**TOWN OF HERNDON, VIRGINIA
ARCHITECTURAL REVIEW BOARD
WORK SESSION AGENDA
JUNE 3, 2020
HERNDON COUNCIL CHAMBERS BUILDING
765 LYNN STREET
7:30 P.M.**

Case Number & Type: ARB #20-014; Wall Sign(s)
Case Summary: Install two (2) new wall sign on the parapet of an existing commercial office building.
Case Location: 12900 Worldgate Drive

Subject: Discussion Item – Park Place Zoning Map Amendment Design Review

PARK PLACE
ZONING MAP
AMENDMENT
TOWN OF HERNDON, VA

**OVERALL
ILLUSTRATIVE
PLAN**

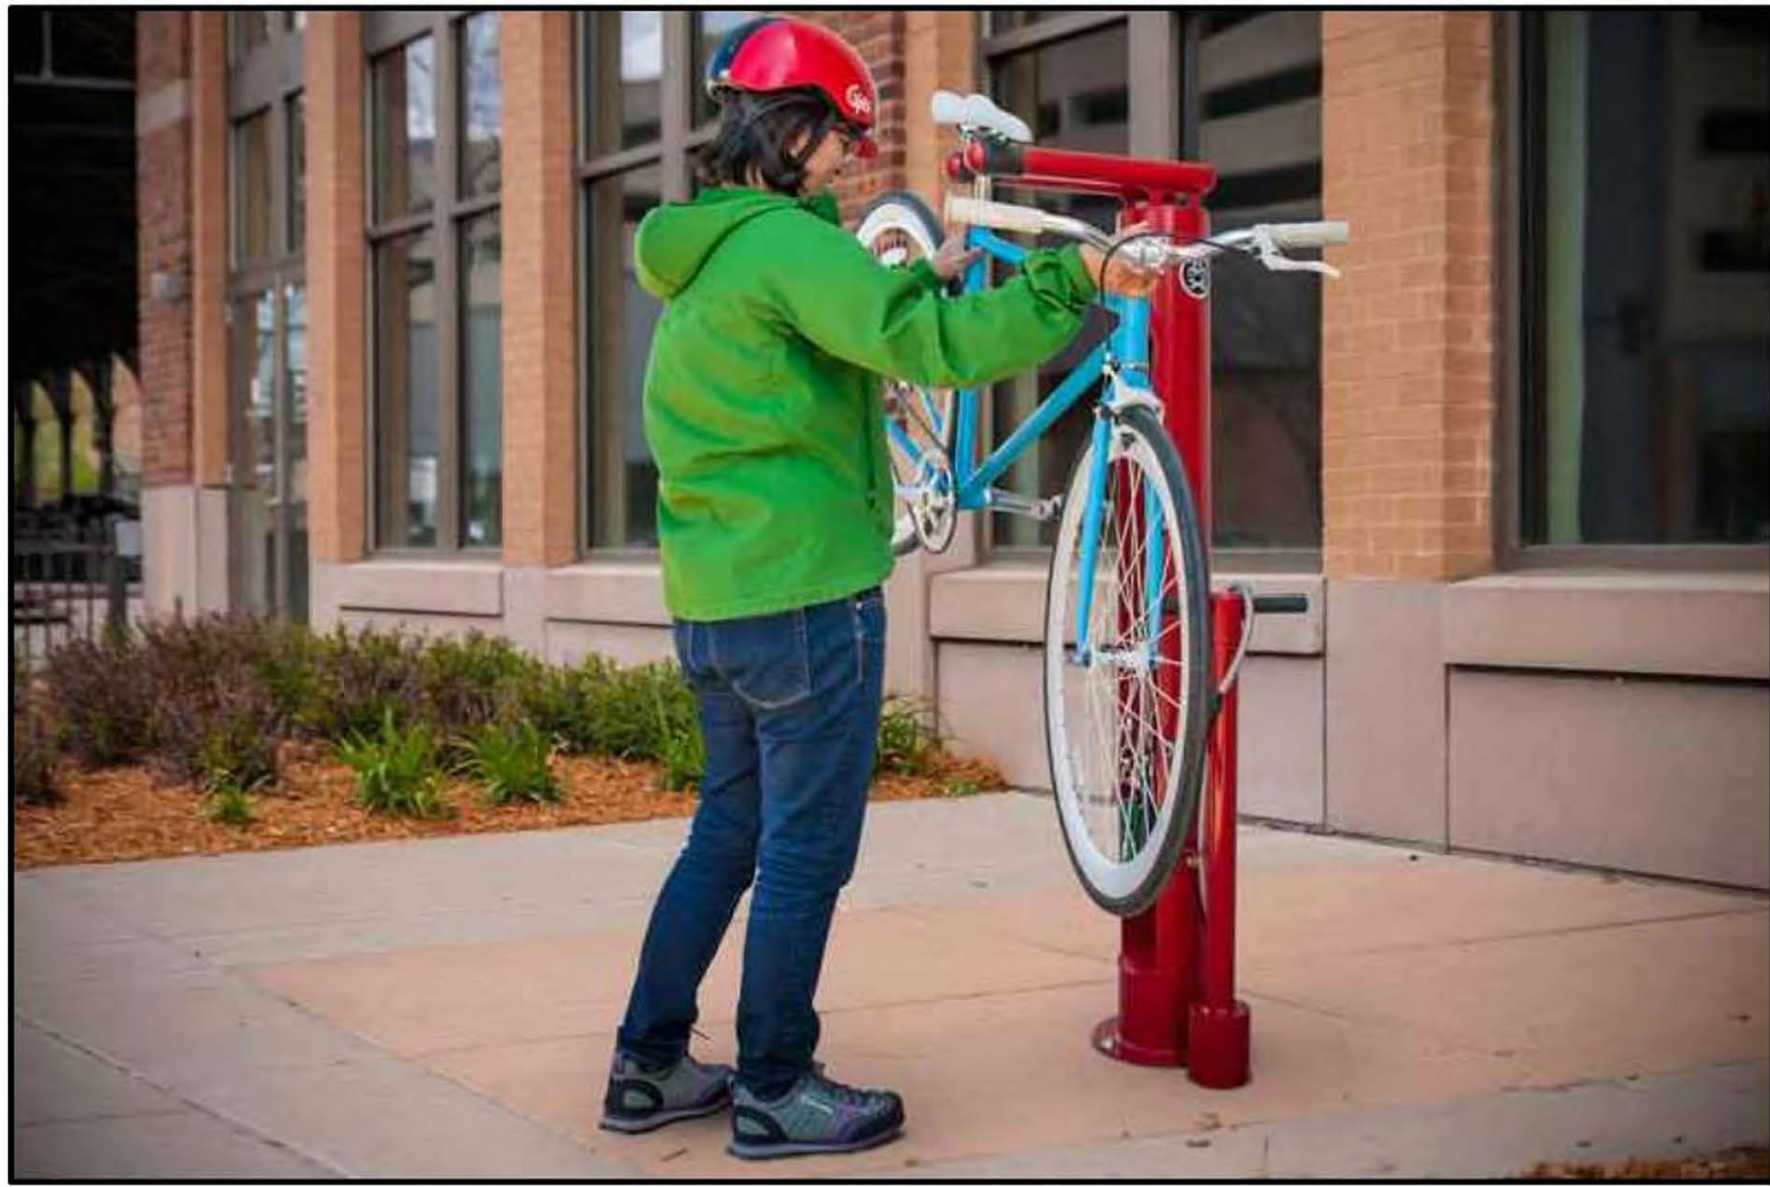
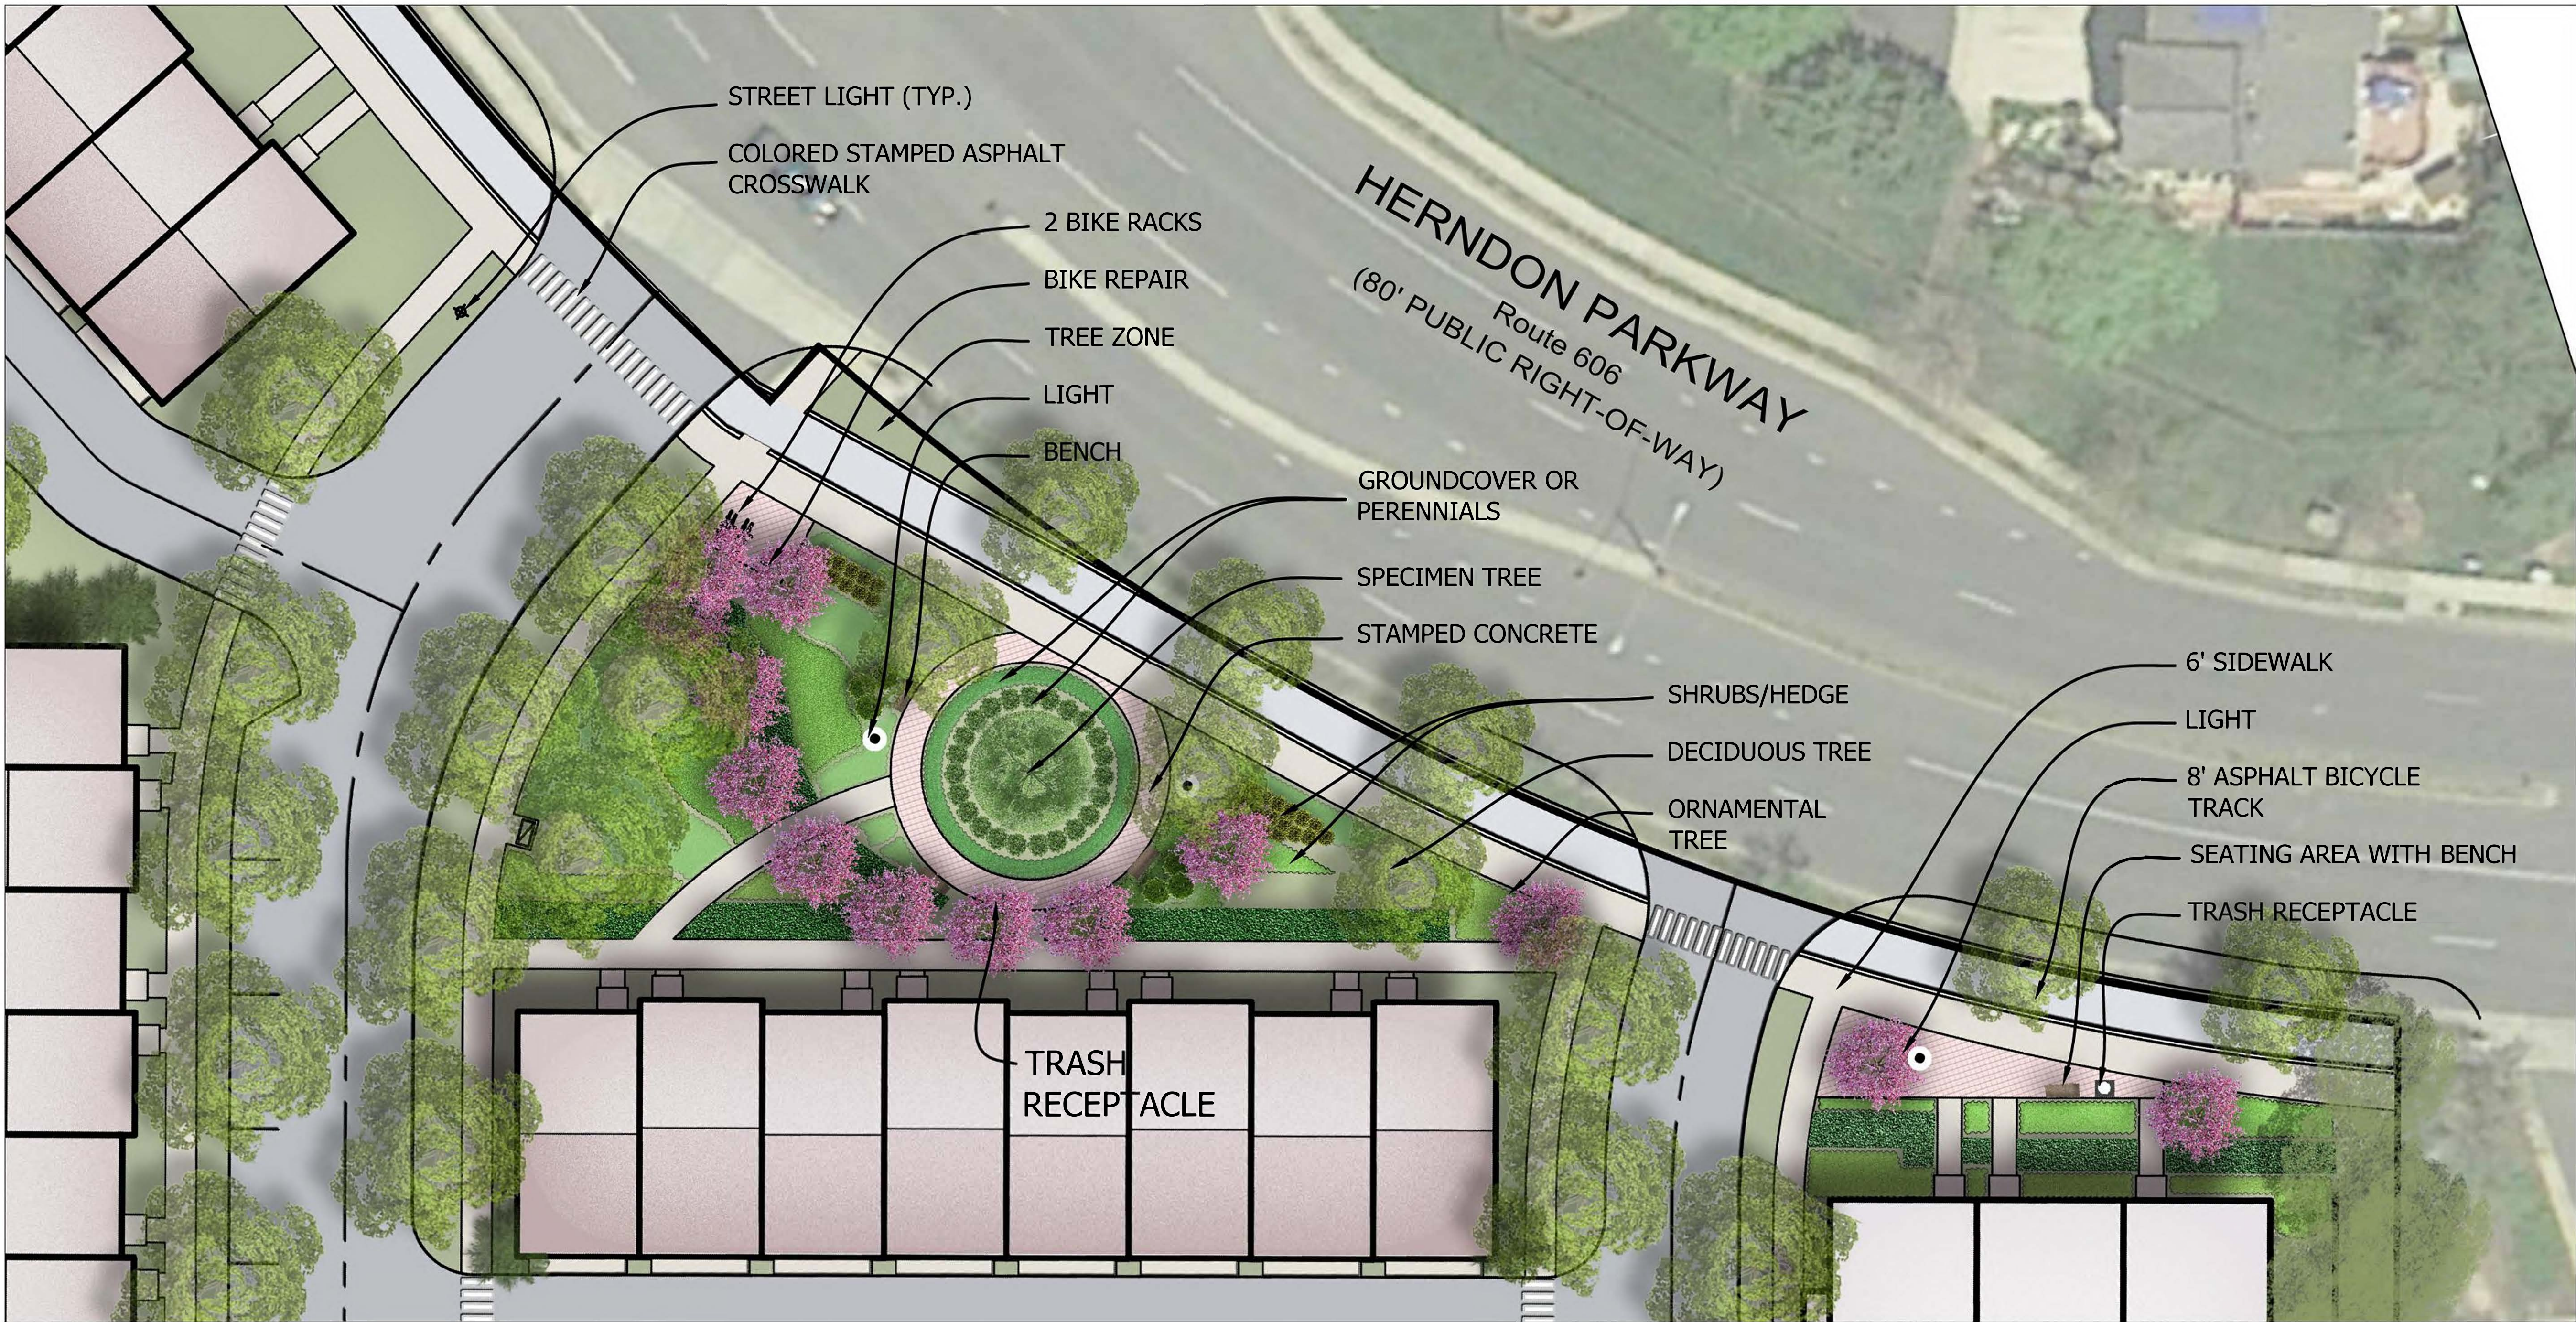
6) Open Space Design:

The designs of the open spaces are only partially understood with the provision of plan views. Perspectives views showing the rendering of the open space designs in an environmental context with relation to the proposed building will help to evaluate their designs. As shown the open space designs are simple and very traditional with walking paths and lawn areas arranged in symmetrical compositions. There is also very limited variation in surface materials and the materials proposed, concrete and stamped concrete suffer from the same dearth of design quality as the overall landscape architecture. As an urban residential product, there is an expectation that more diverse and unique open space concepts would be offered, and higher quality materials such as pavers or textured pathways would be used.
